INVITATION TO TENDER "ITT" No. PS20181181  
CONSTRUCTION SERVICES FOR THE GRANVILLE BRIDGE STRUCTURAL REPAIR

ADDENDUM No. 1

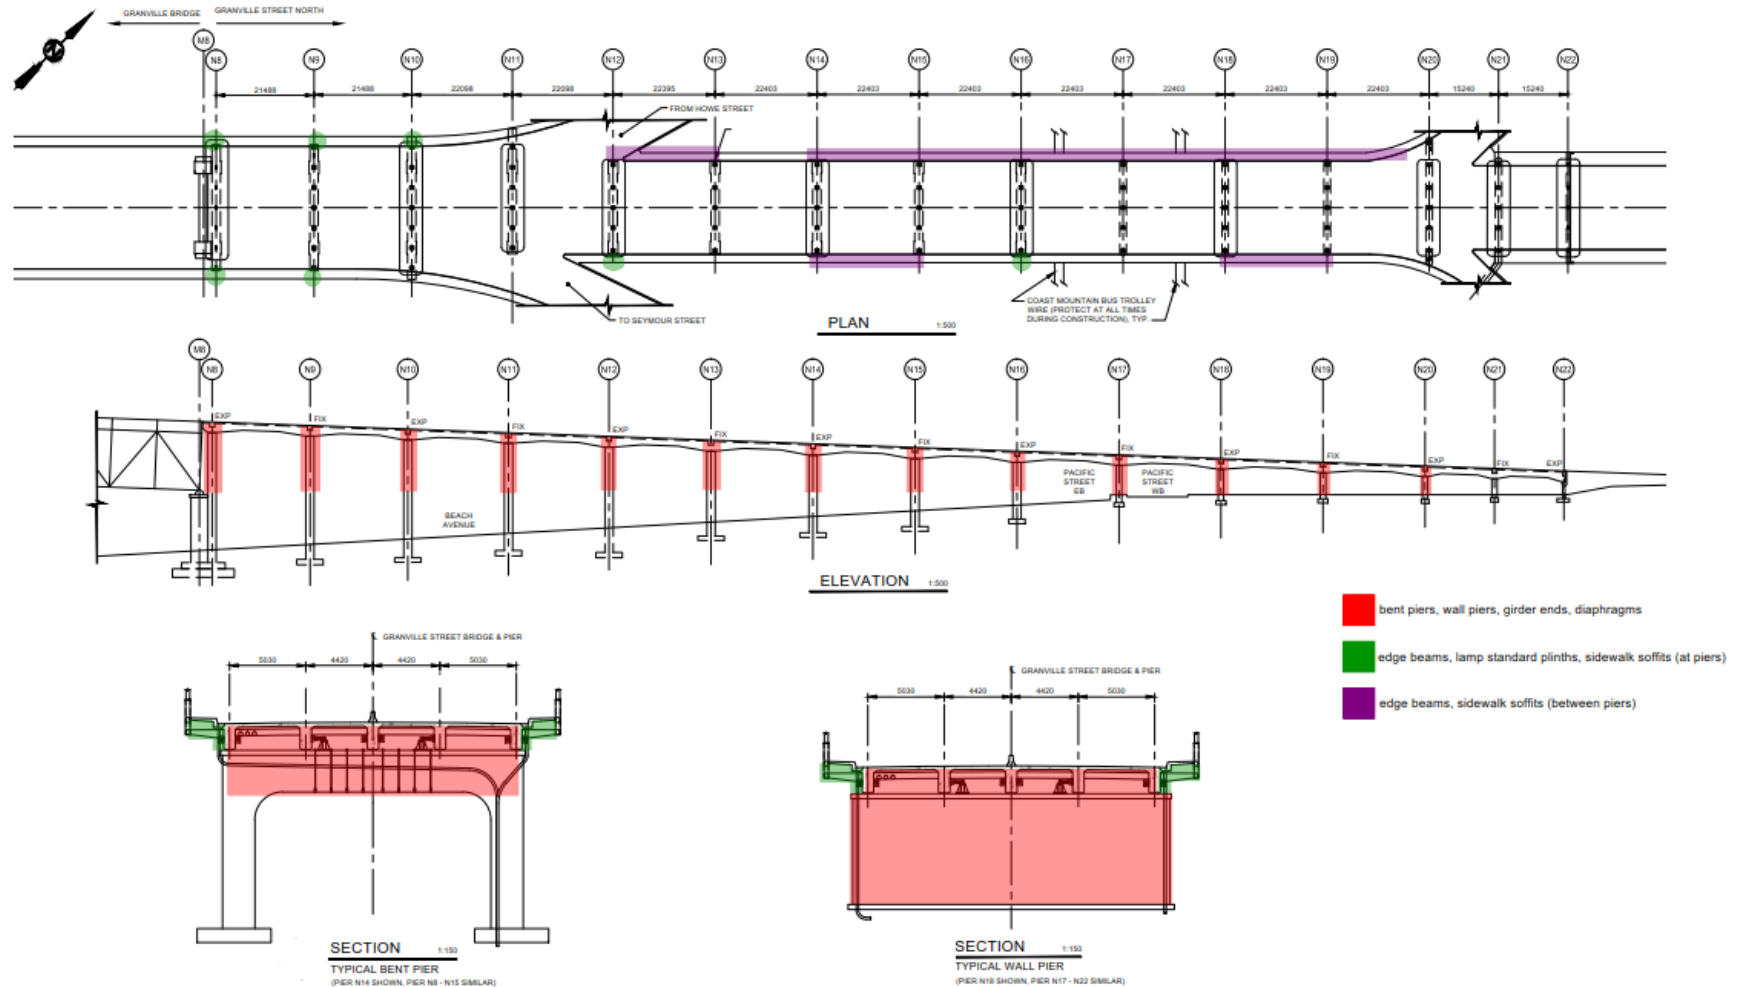
"Provide safe access to the required elevated portions of the girders, deck soffit, and piers in order to complete the delamination inspections and concrete repairs. Areas requiring access for concrete repairs are shown in the sketch below.

i. Delete and replace clause 3.3.1 with the following:
